Model: Met-MF3		Date: 25-Jan-19	No.: RD0BL001
Subject: Announcement for Customer Engineer Tool		Prepared by: Y. Taniguchi	
From: Technical Support Sect., Service Strategy Dept.			
Classification:	<input type="checkbox"/> Troubleshooting <input type="checkbox"/> Mechanical <input type="checkbox"/> Paper path <input type="checkbox"/> Product Safety	<input type="checkbox"/> Part information <input type="checkbox"/> Electrical <input type="checkbox"/> Transmit/receive Other ()	Action required Service manual revision Retrofit information Tier 2 Tier 0.5

An SOP application which can support the maintenance operations is released.

Fig. 1

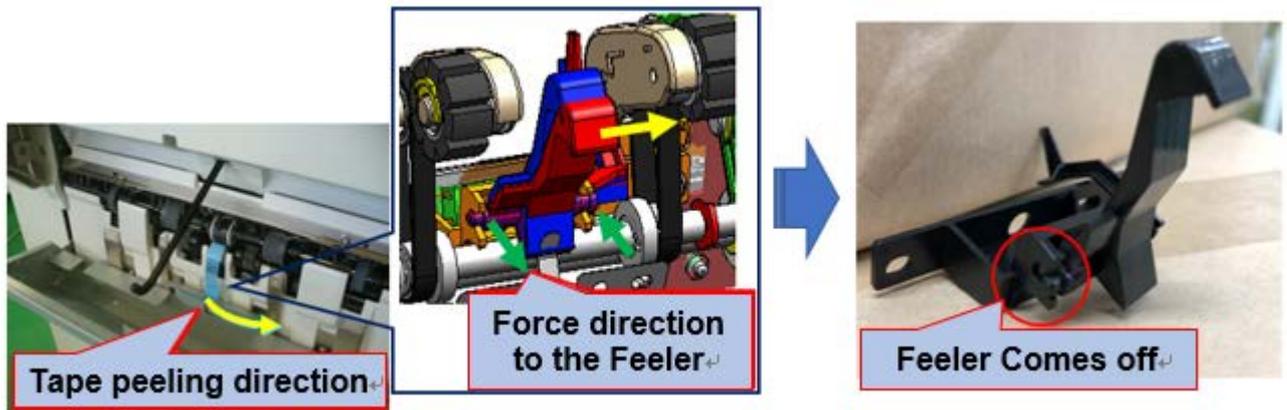
Because the force is applied in the direction in which the "Paper sensor feeler" is come off when removing the packaging tape of the "Paper sensor feeler" at the time of unpacking & installation. (Refer the Fig. 1 shown as below)

Change the tape peeling procedure.

Peel the packaging tape straight up and pull out the protective member, when peeling off the packaging tape of the “Paper Sensor feeler”. (Refer the Fig. 2 shown as below)

Fig. 4

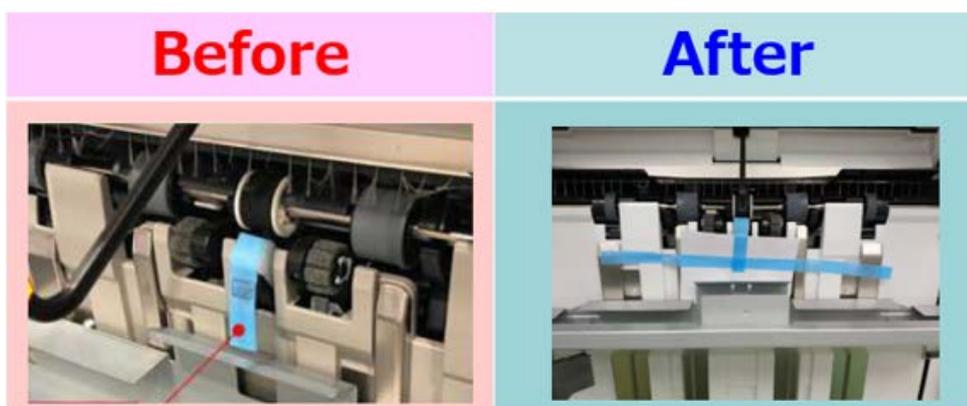
Change the “Paper Sensor feeler” fixing method

Modification to “Not tap to Feeler” from “Tape to Feeler” is applied from March, 2019. See the Change as below Fig. 4. And the procedure described this RTB is not required with those Finisher.

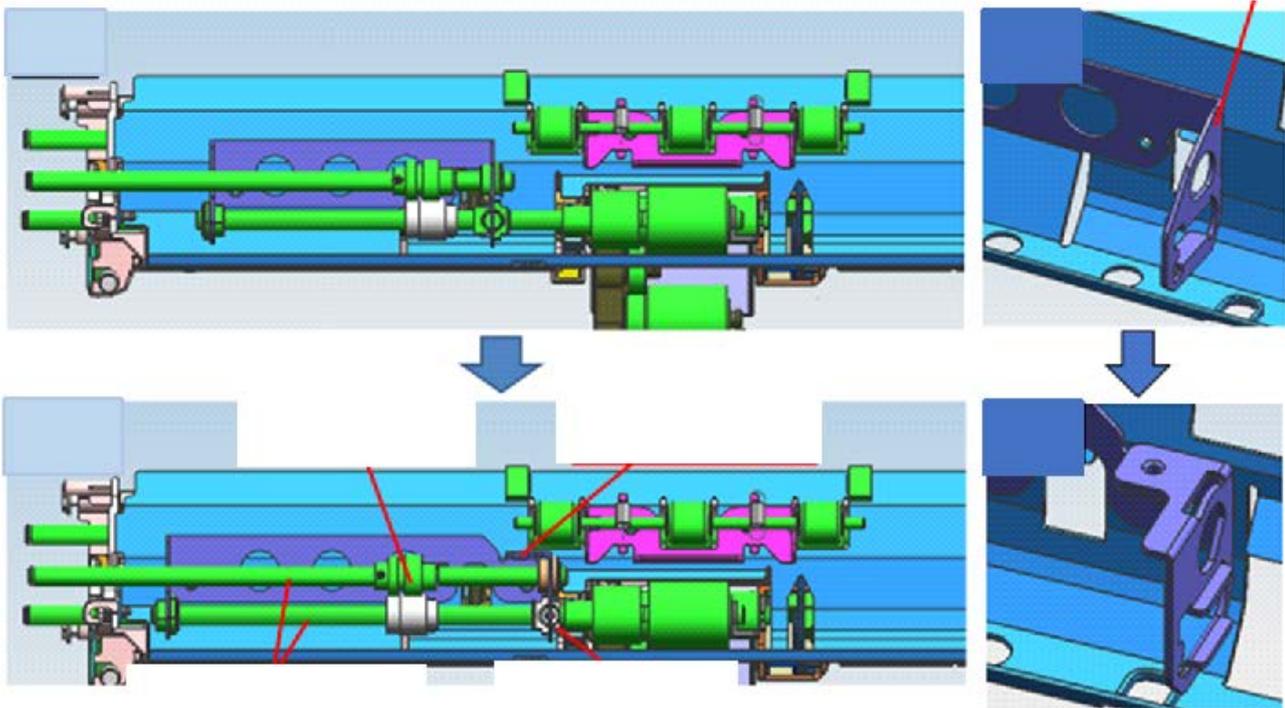
Change 3: The shape of the brackets and bearings, length of the roller shaft, and the gear position has changed. Also e-rings added.

Old P/N <Group B>	New P/N	Description	Int	Q'ty	Note
08050104	08050104	RETAINING RINGS-E:SILENCER:DIA4	-	2->3	C
D1494770	D0BQ2608	SHAFT:SEPARATOR:DRIVEN:ASS'Y	X/X	1	C
M0BW2615	D0BQ2615	GUIDE PLATE:SEPARATOR:ASS'Y	X/X	1	C
D1492619	D0BQ2619	SHAFT:SEPARATOR:DRIVE:ASS'Y	X/X	1	C
D2412653	D0BQ2653	COIL SPRING:PRESSURE:SEPARATOR	X/X	1	C

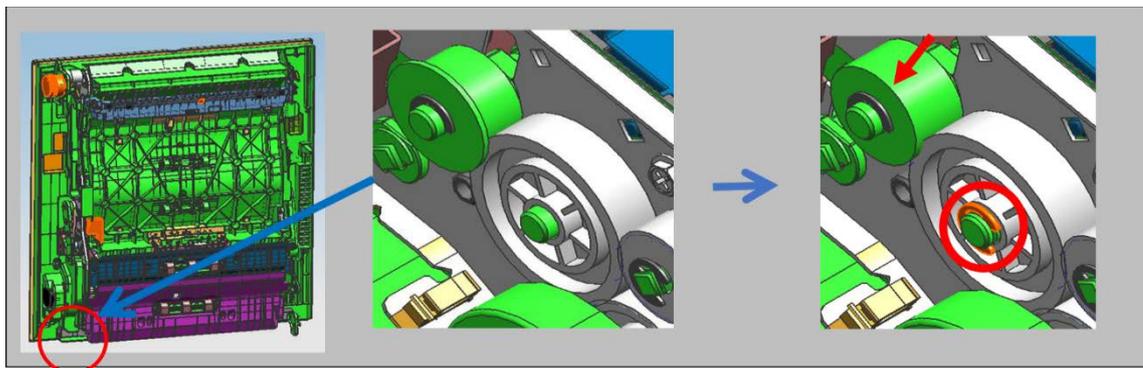
Change 4: There are no protruding parts to hold the gear. An e-ring added to stop the gear in position, and a groove added to the shaft for the e-ring.

Old P/N <Group B>	New P/N	Description	Int	Q'ty	Note
07200040E	07200040E	RETAINING RING - M4	-	3->4	D
D2414631	D0BQ4631	SIDE PLATE:REAR:DUPLX:PEEN	X/X	1	D
D2414644	D0BQ4644	GEAR:MECHANICAL ROLLER CLUTCH	X/X	1	D

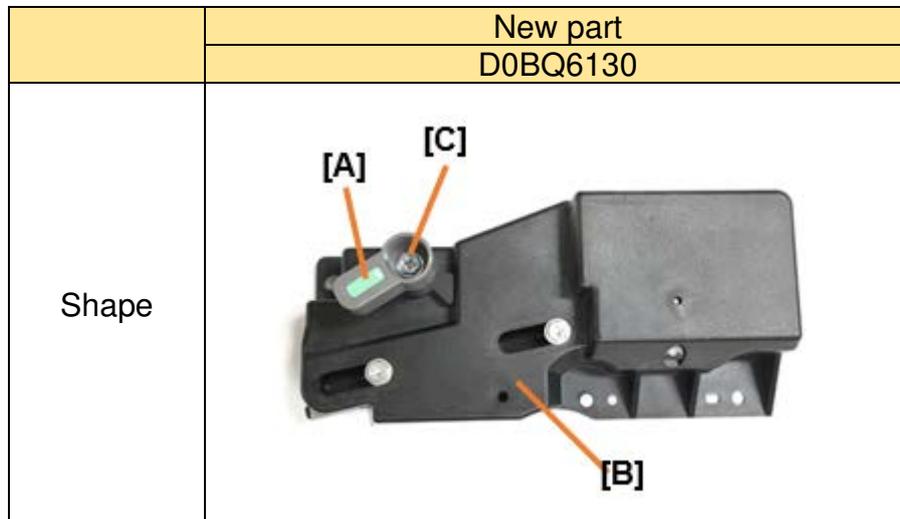
The lever and the toner outlet unit might need to be replaced at the same time due to the above change. A set (**D0BQ6130**) including both parts is now available (as shown in the picture below).

Change: The shape of the metal lever shaft has been changed slightly. The metal lever shaft is attached to the toner outlet unit[B].

Change:

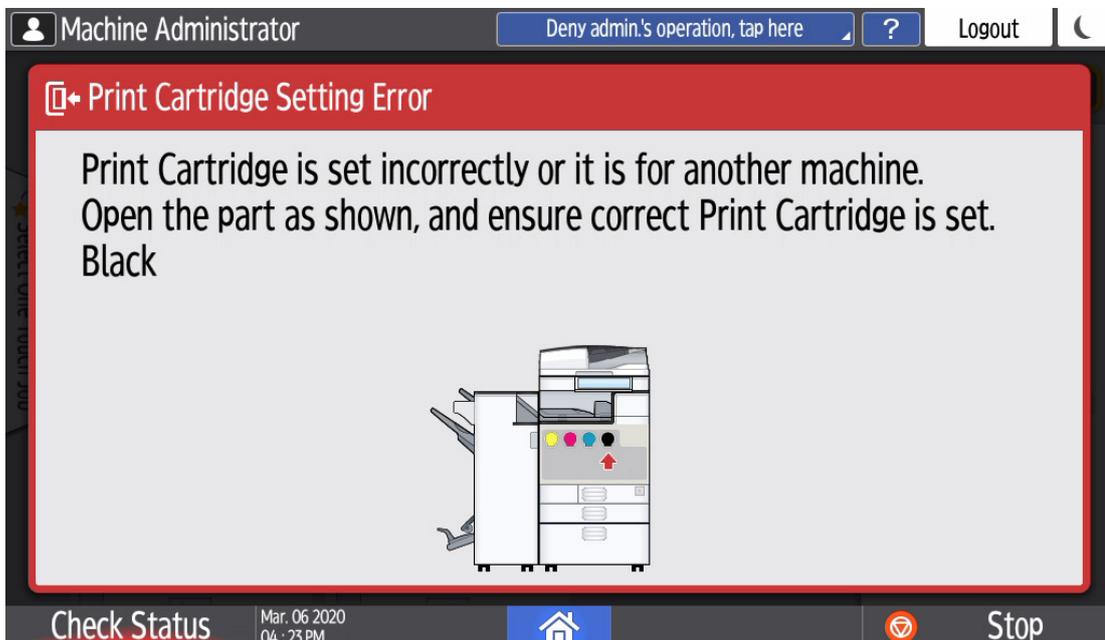
If the region code of the toner cartridge does not match the machine’s region, an alert message will appear on the screen and the printing features (Copy/Printer/FAX/Others) will be locked.

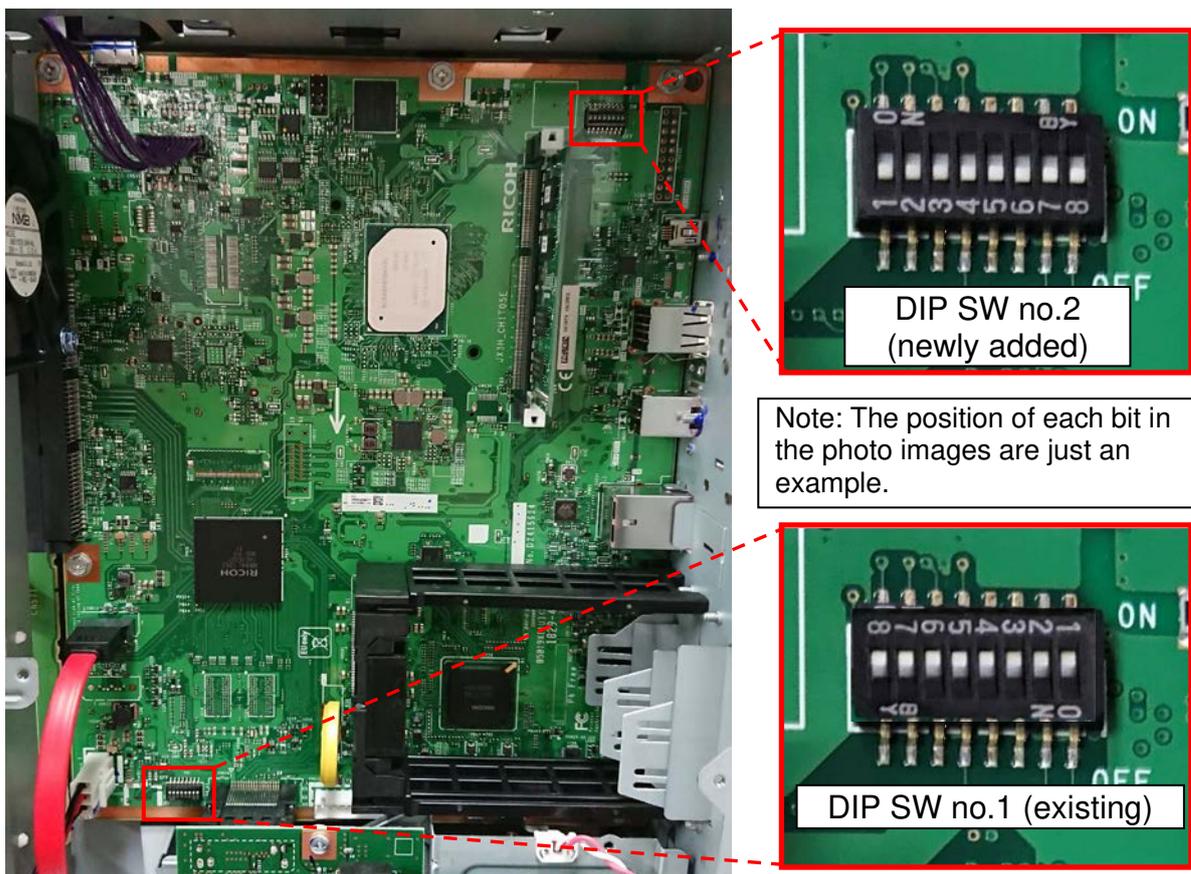
A DIP switch no.2 has been added on the Controller board as the following photo image. This is for the purpose of factory QA management so **no utilization for service operation in the field.**

Important: Please be sure not to change the settings of DIP SW no.1 and no.2 in the field. Correct setting depends on each Controller Board and SC672 or other symptom may occur if the machine is booted with an incorrect setting.
